ALLEGHENY COUNTY SANITARY AUTHORITY

CONTRACT NO. 1729 G, E, H, P

EAST HEADWORKS

ADDENDUM NO. 3

ALLEGHENY COUNTY SANITARY AUTHORITY
WASTEWATER TREATMENT PLANT
EAST HEADWORKS
CD-10
CIVIL SITE DETAILS

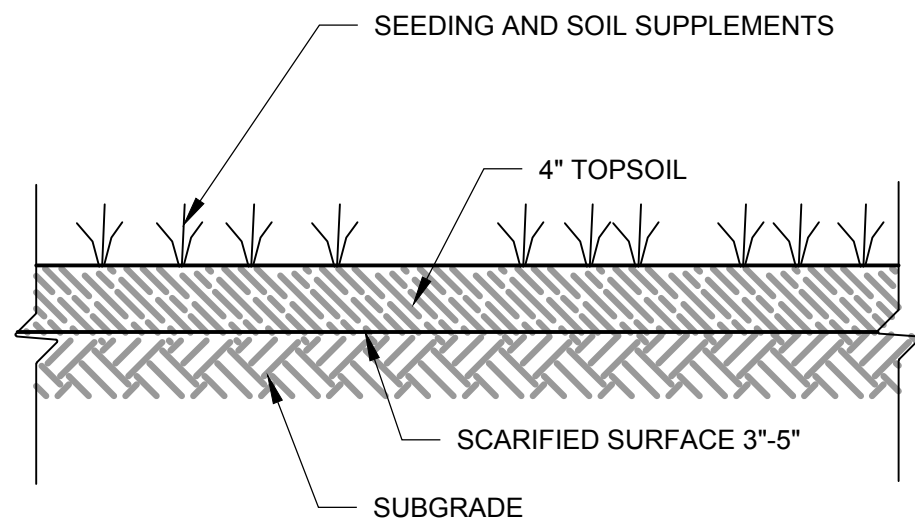
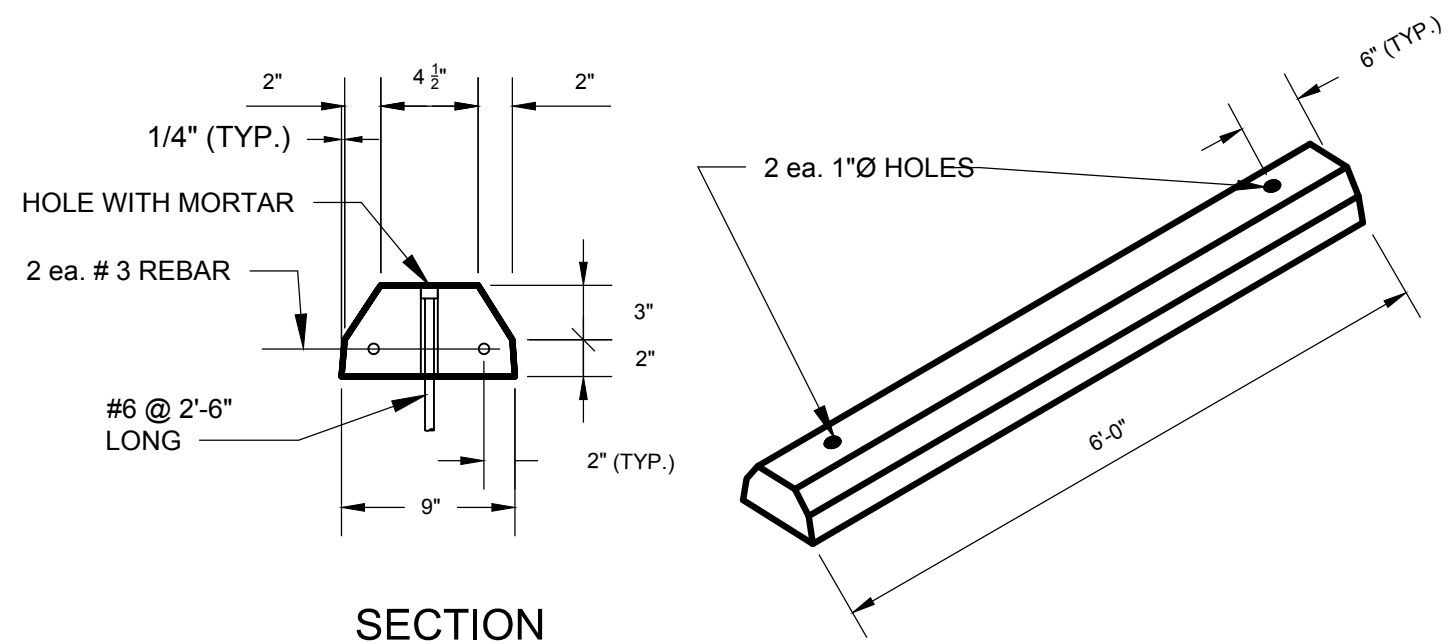
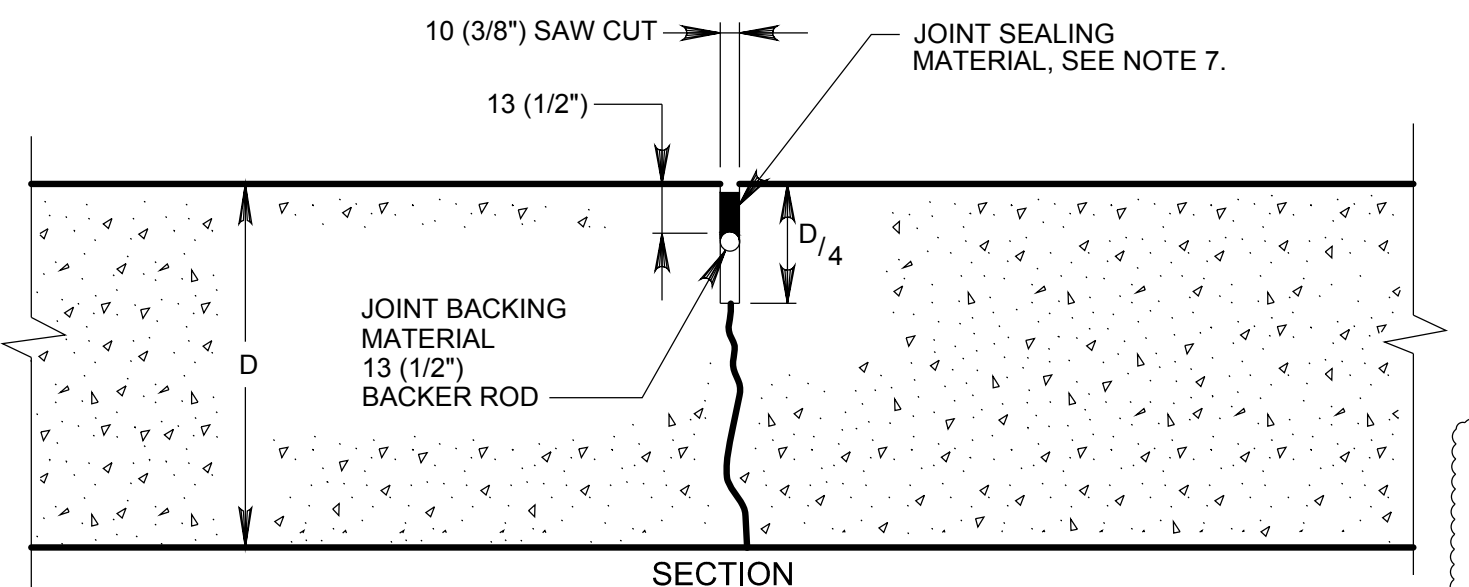
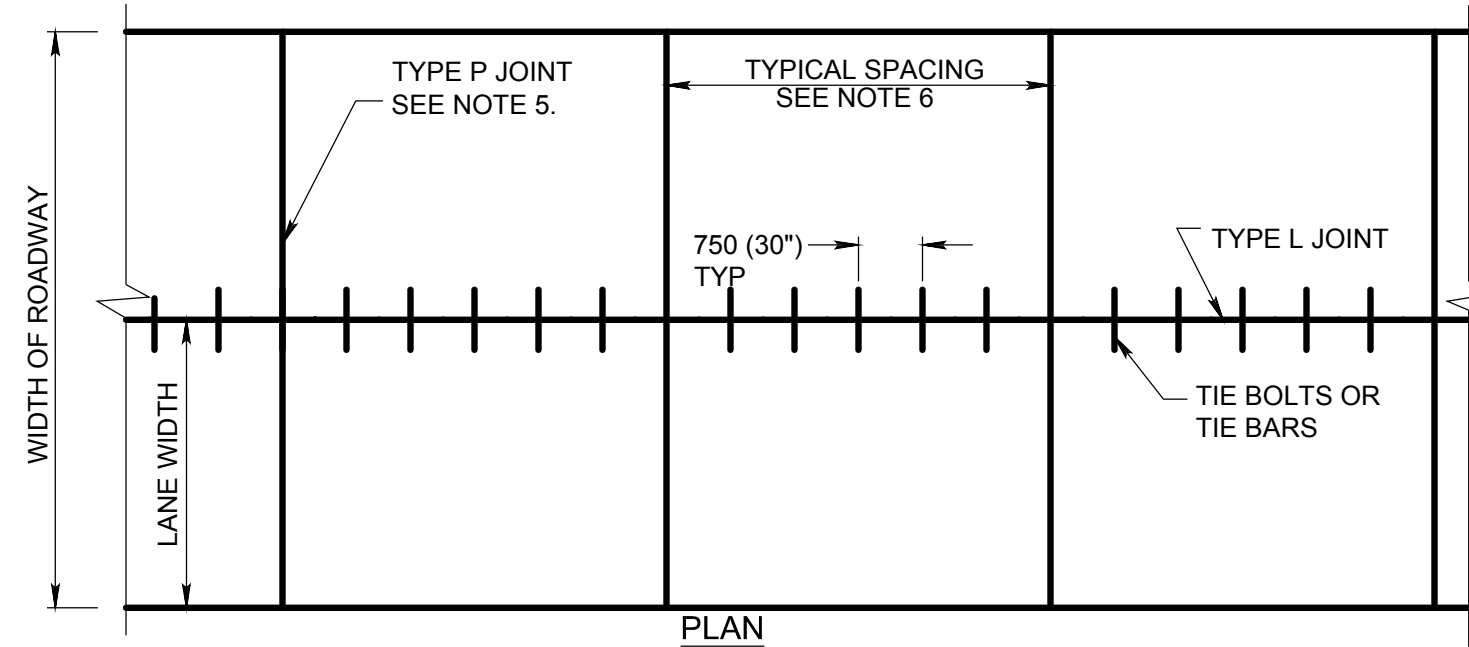
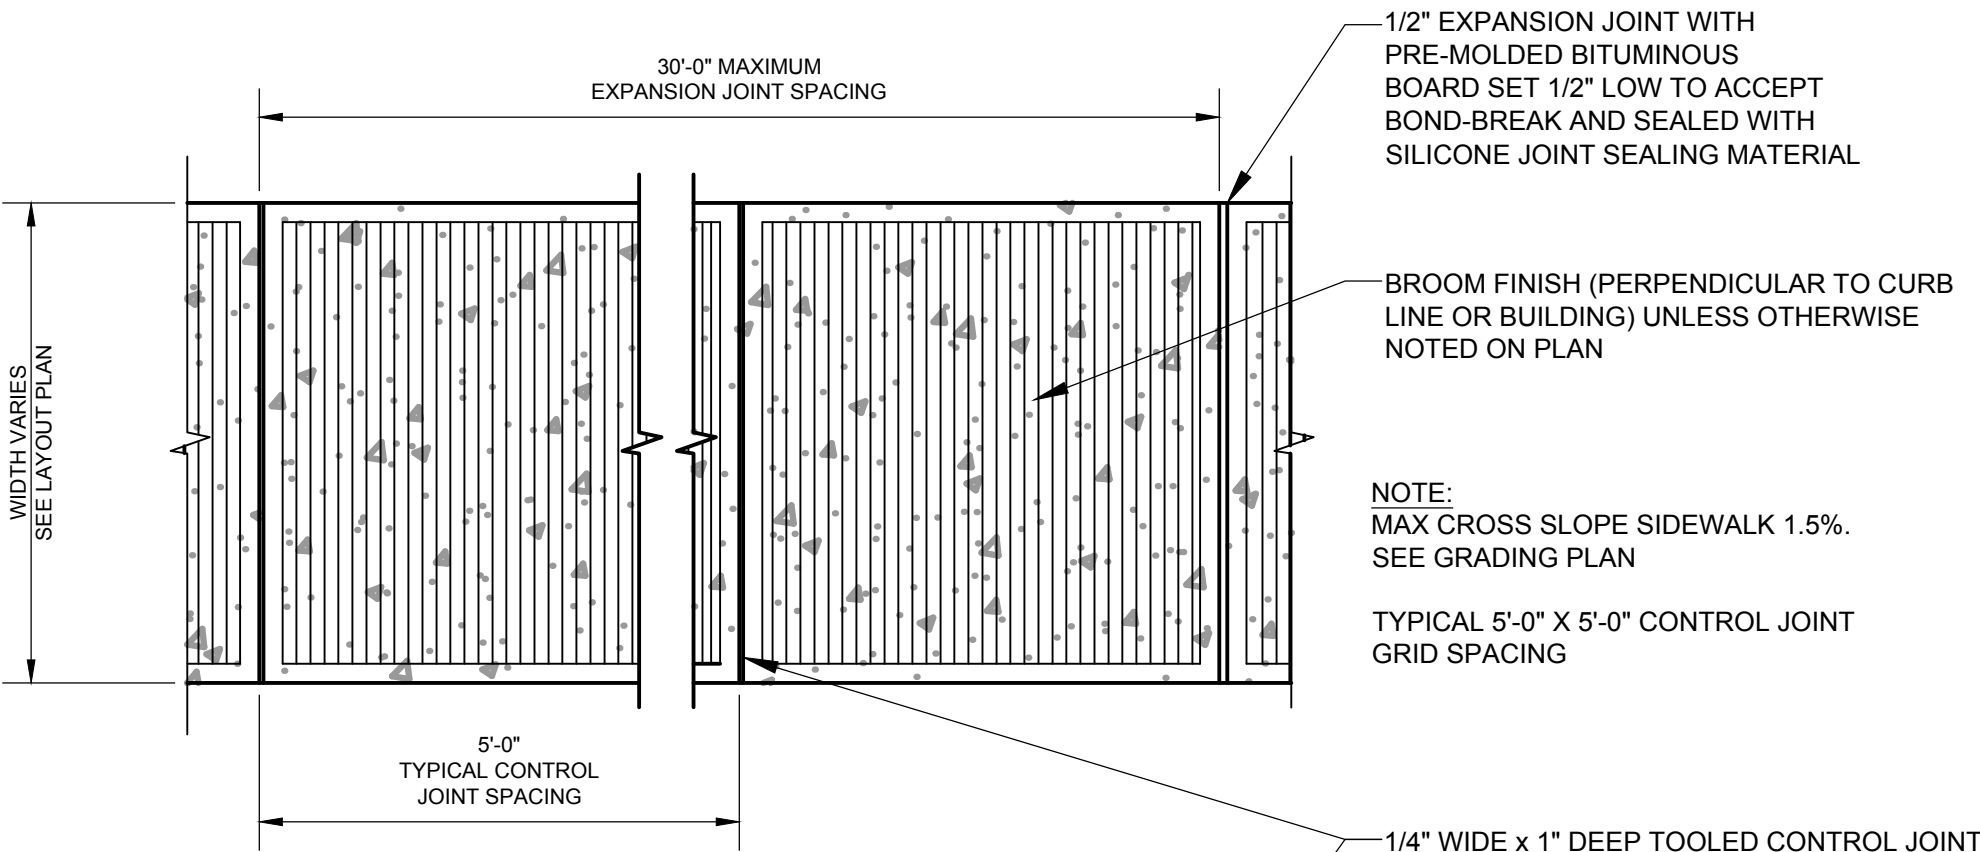
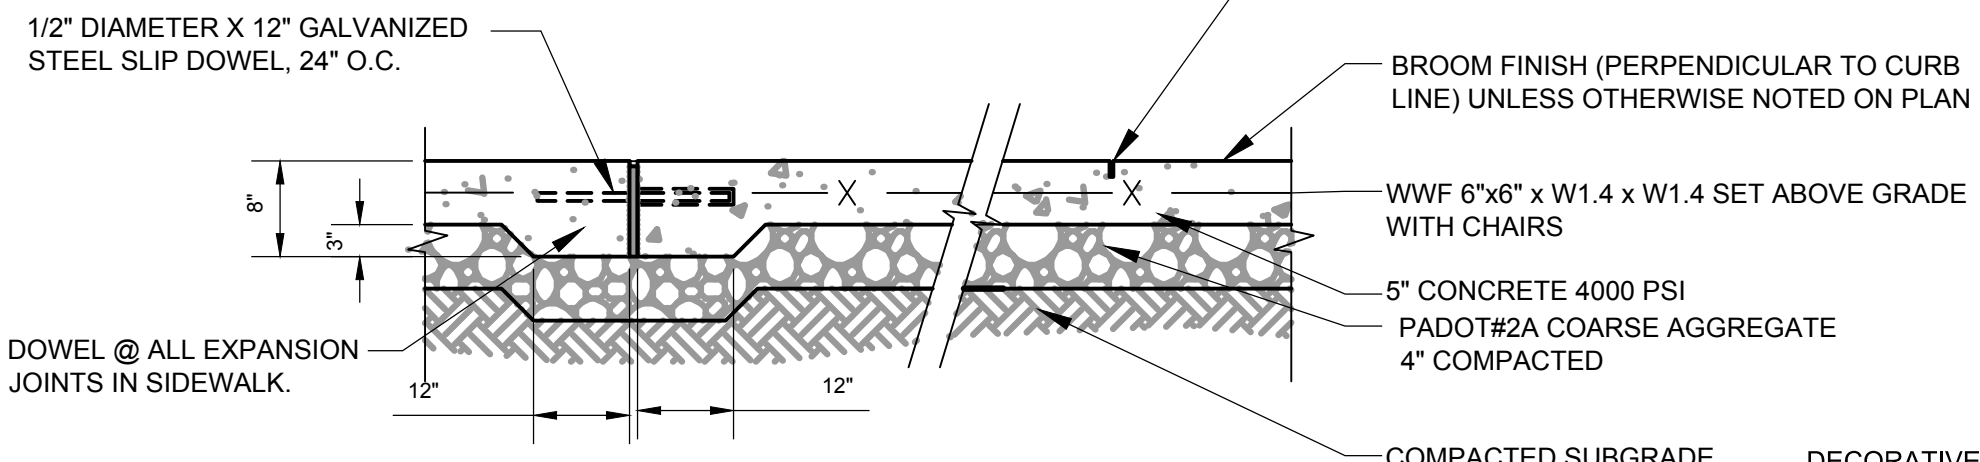
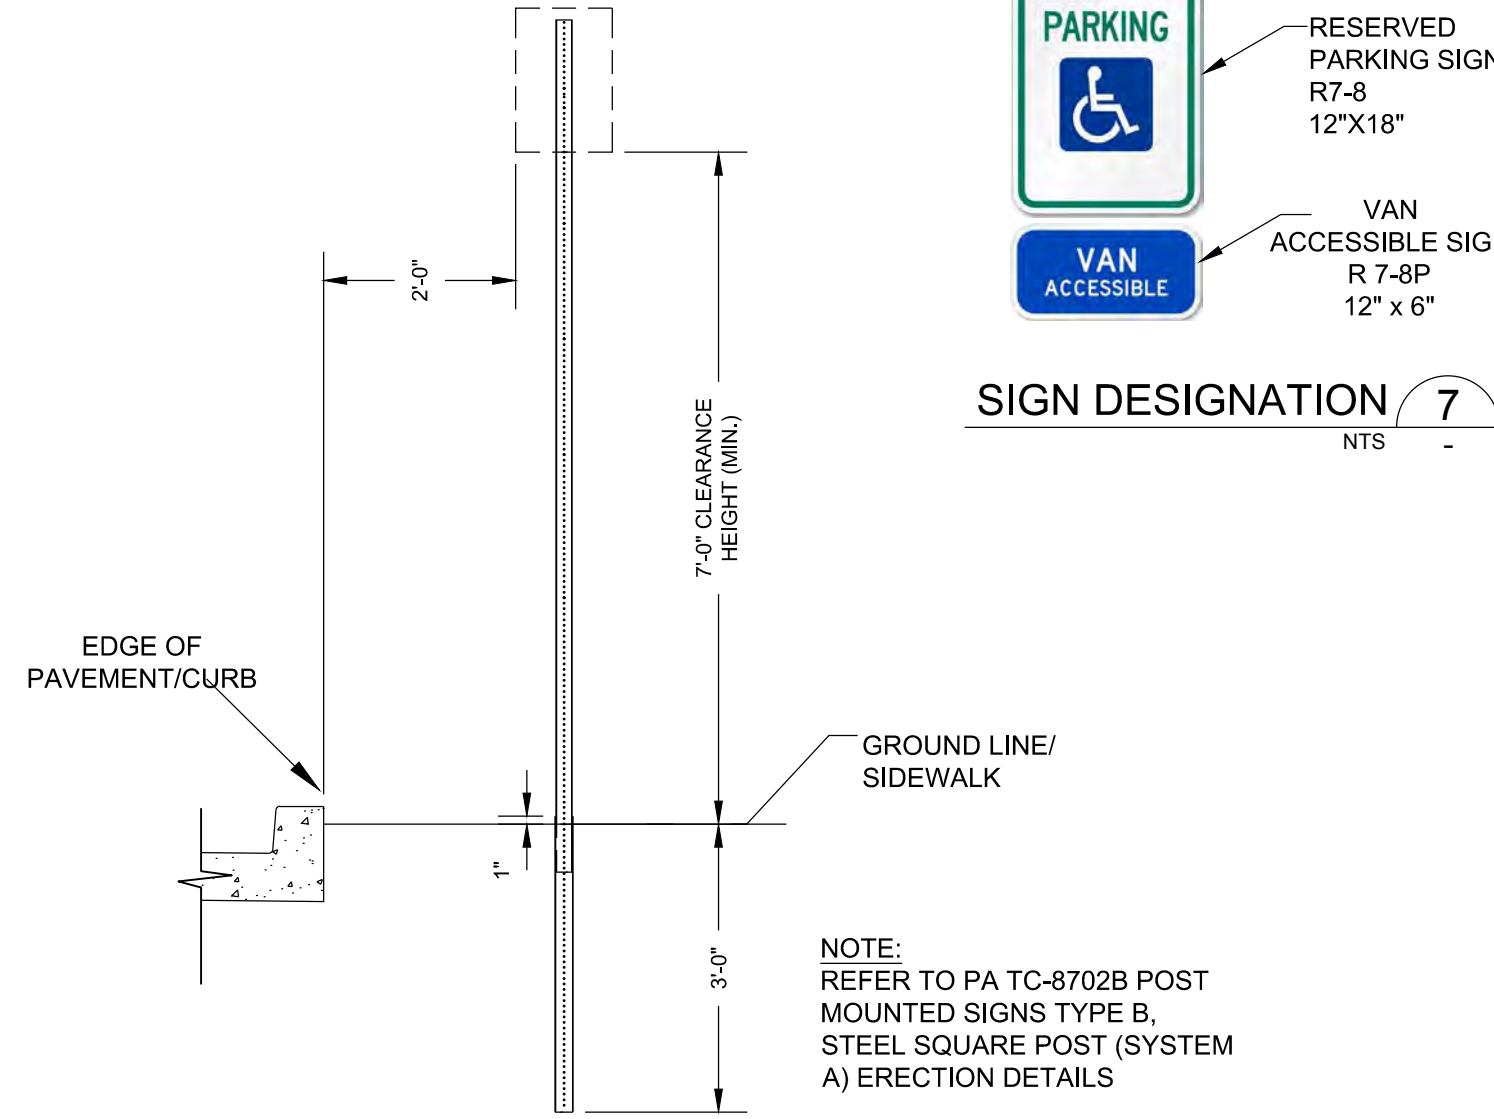
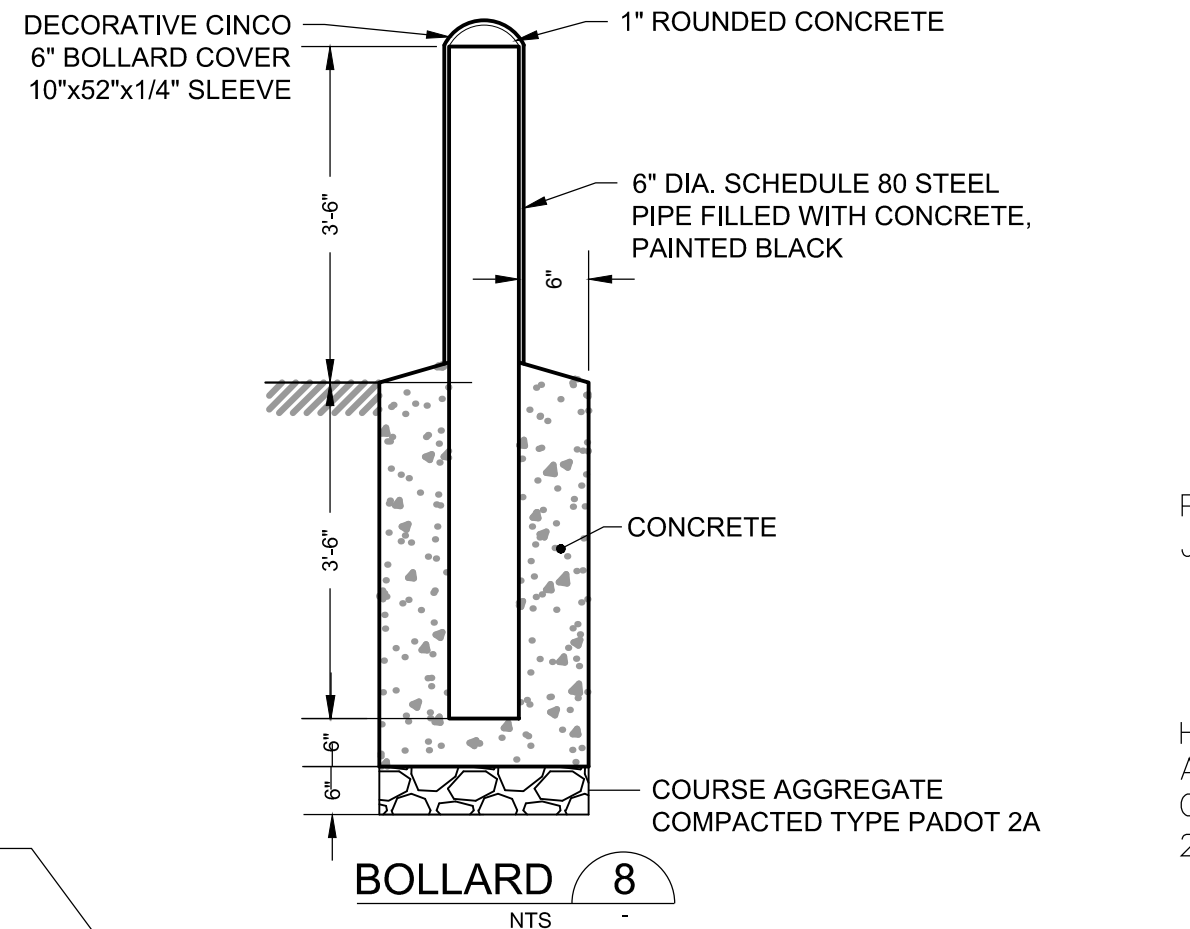
2. Drawing CD-10

- a) DELETE this drawing and REPLACE with the attached drawing CD-10.
